Oregon State University
Construction Contract Administration
MERRYFIELD HALL RENOVATION

ADDENDUM NO. 5

Subject: OSU Merryfield Hall Renovation Project

DWG. NO.
S2.1
6 of 16
160553-B

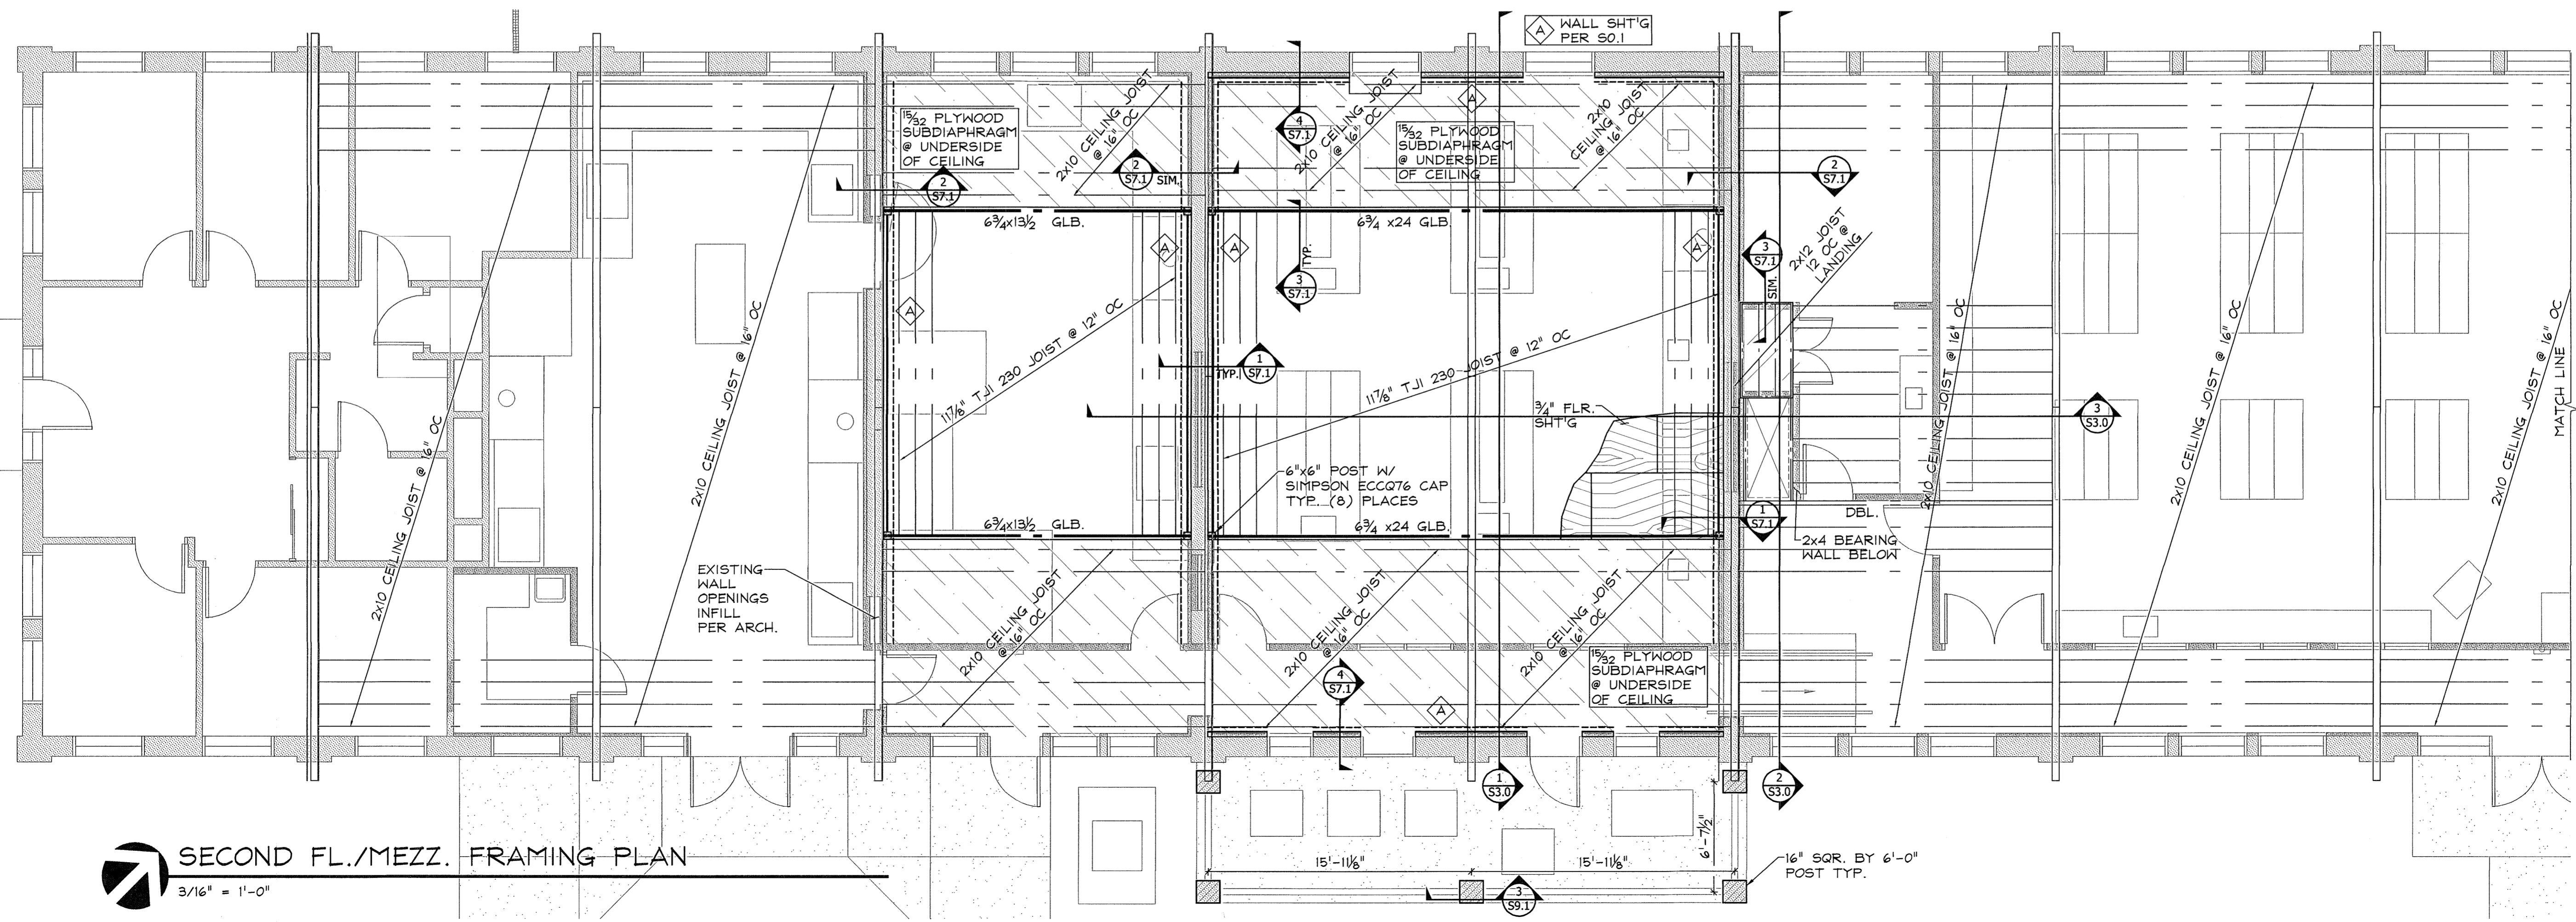
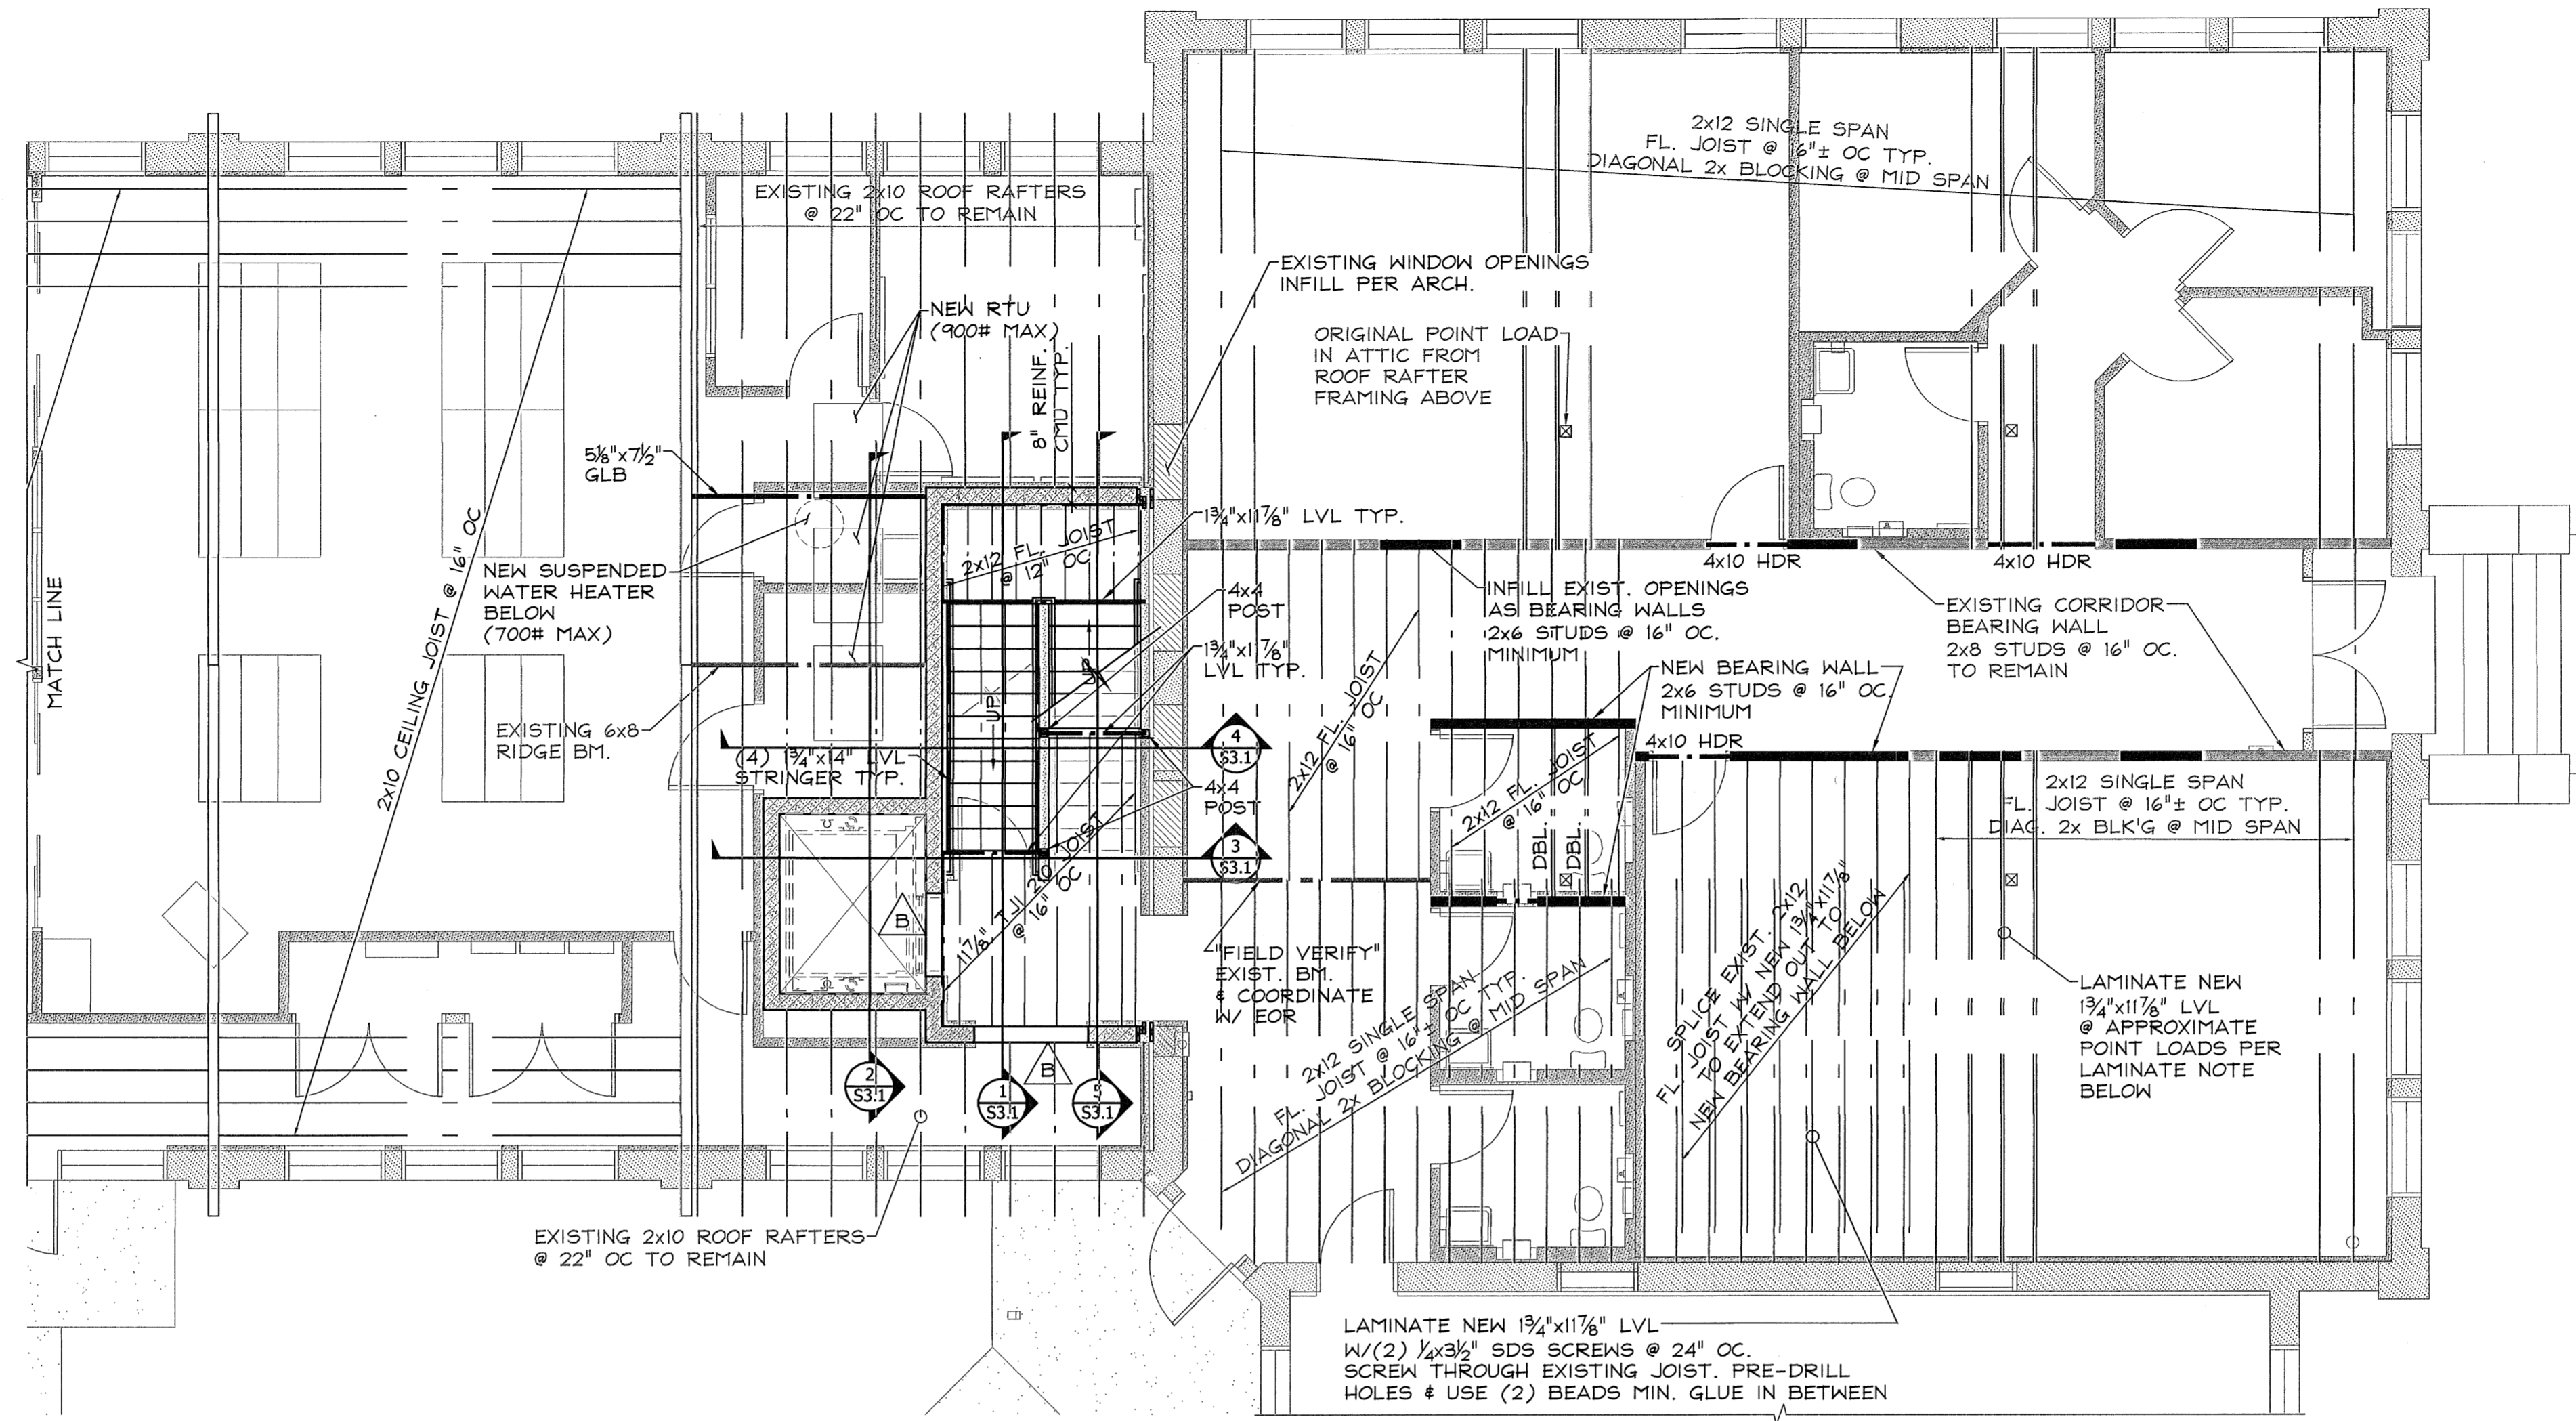
- 2) Sheet S2.1 Second Floor Framing Plan and S2.2 Roof Framing Plan - Clarification: The existing joists have been shown with a lighter line weight. This light line weight did not come across clearly on the scanned copies included with the bid documents. The bid drawings indicate some areas where new floor joists are required and one area where new joists are to be spliced onto existing joists. The majority of existing floor joists are to remain. The drawing has been replotted to improve drawing clarity and attached to this addendum.
